AMENDMENT SHEET

**Planning Committee
30 June 2016**

AMENDMENTS OF CONDITIONS AND REPRESENTATIONS RECEIVED

HOLE IN THE WALL FOOTBRIDGE

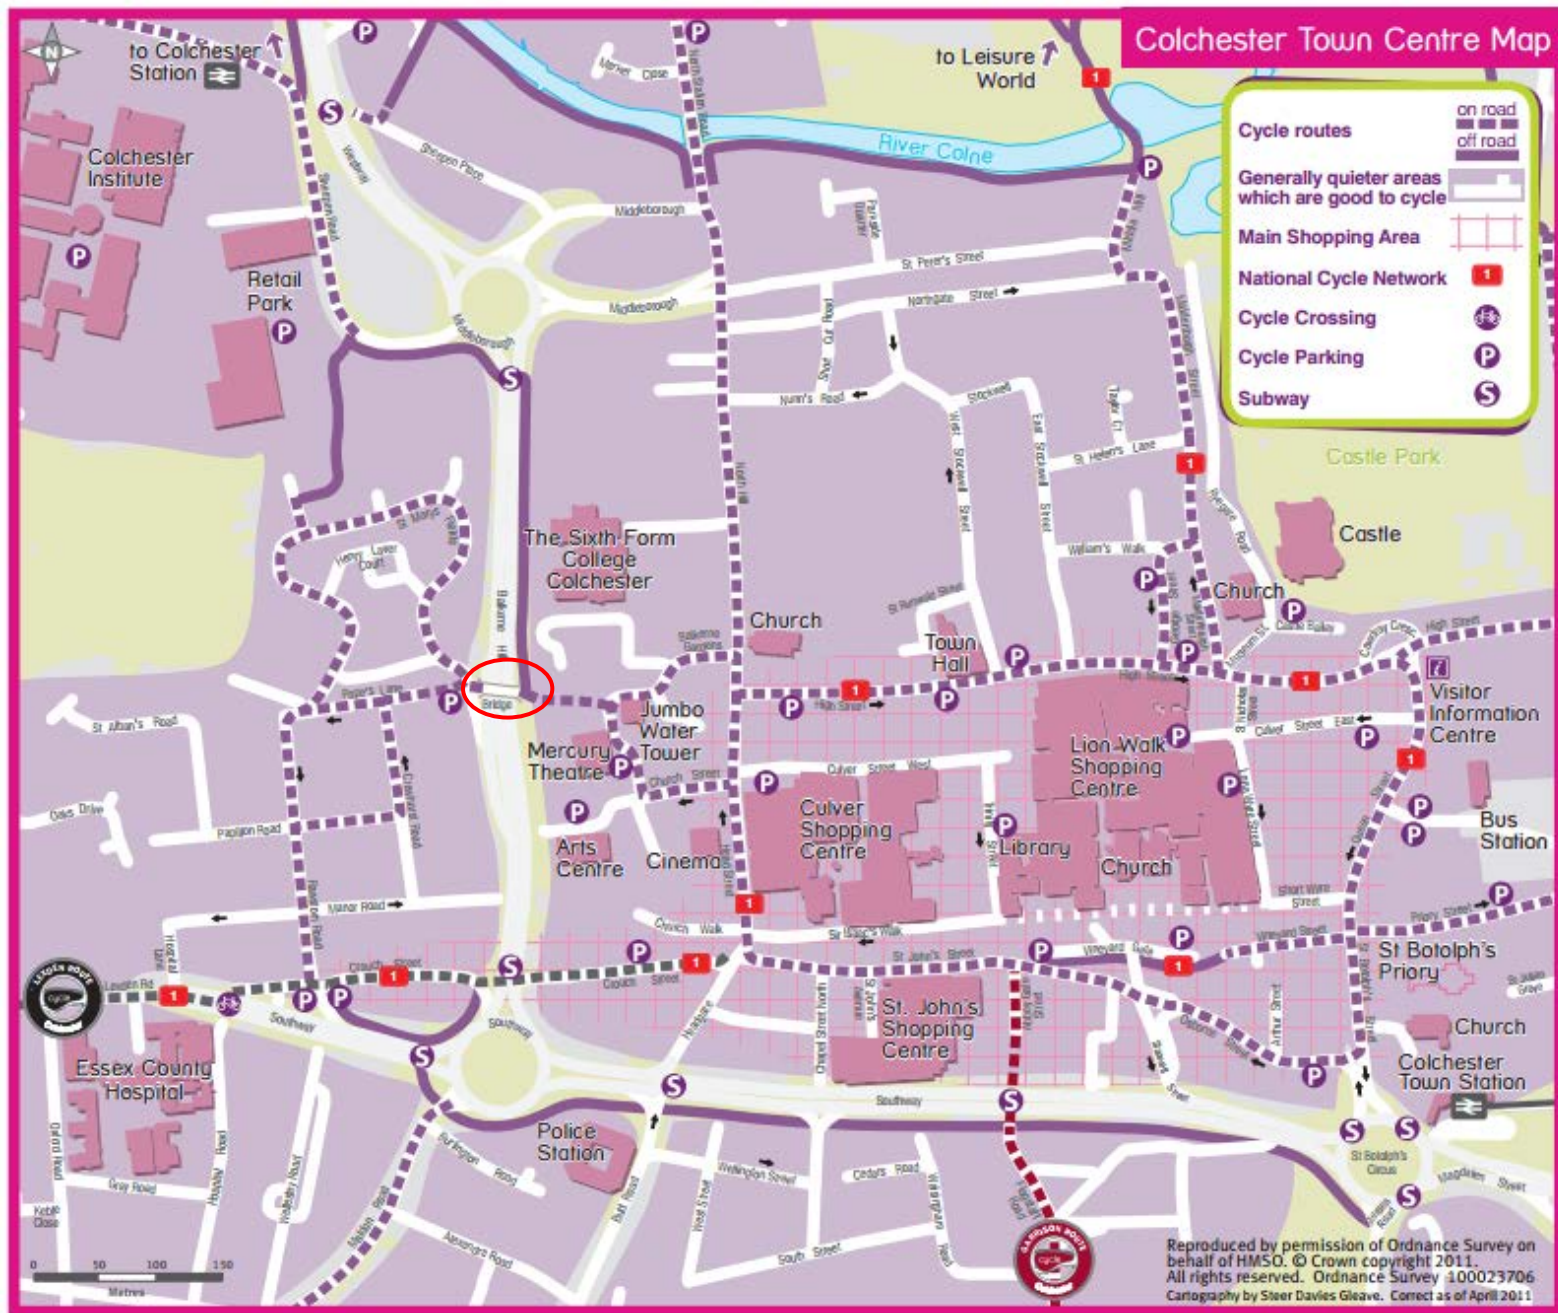
An additional slide is attached (Appendix 1) showing the Town Centre Colchester cycle map.
